S E R V I C E N O T E

8753D Network Analyzer

Power Supply Modification when installing Firmware Rev. 6.14 on older 8753Ds**Parts Required:**

Preregulator Drawing

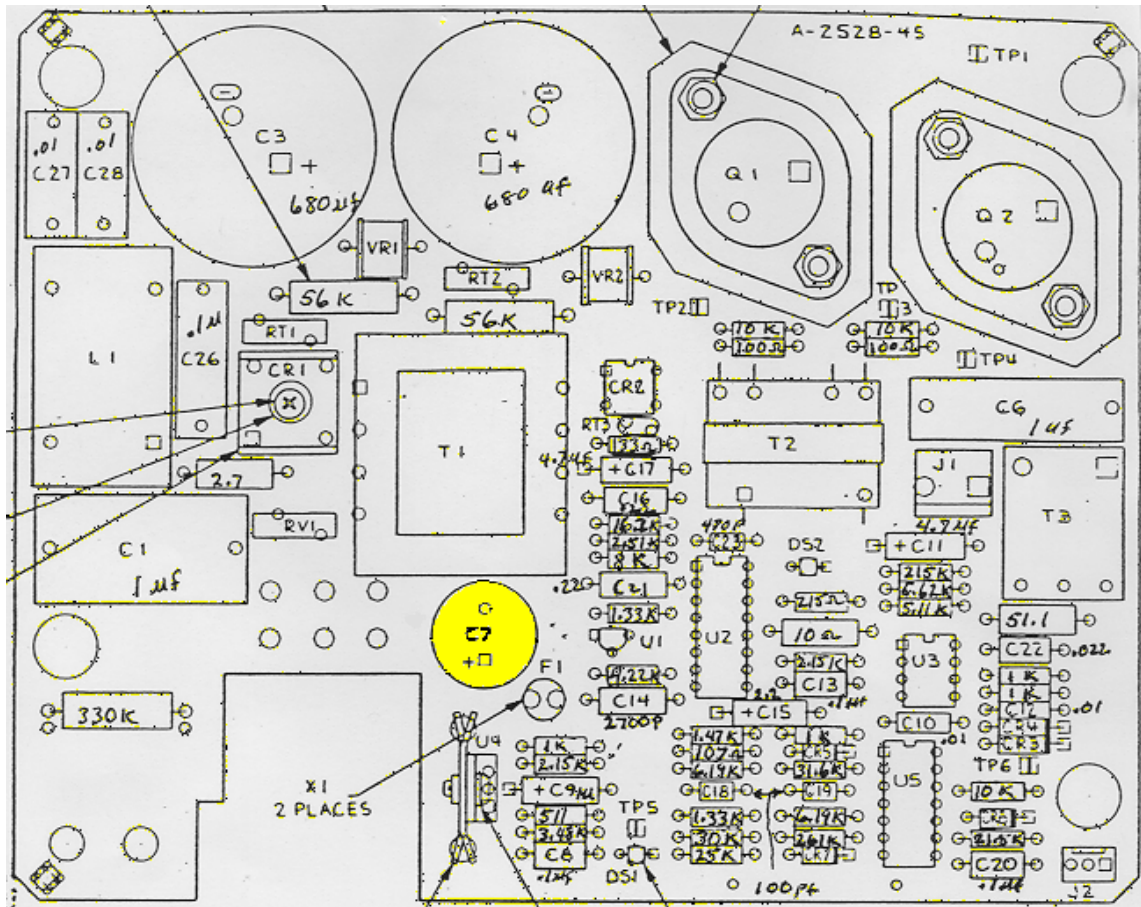
When upgrading to firmware revision 6.14, 8753D units with serial numbers in the above range may demonstrate CRT display problems related to the power down routine of the CPU. Typical symptoms include a blank display, unusual colors or lack of colors after the power has been cycled twice following the insertion of the EPROMs.

Replace capacitor C7 in the power supply preregulator with the part listed above or equivalent. For complete detailed instructions on how to perform this modification, see the installation note supplied in the firmware upgrade kit.
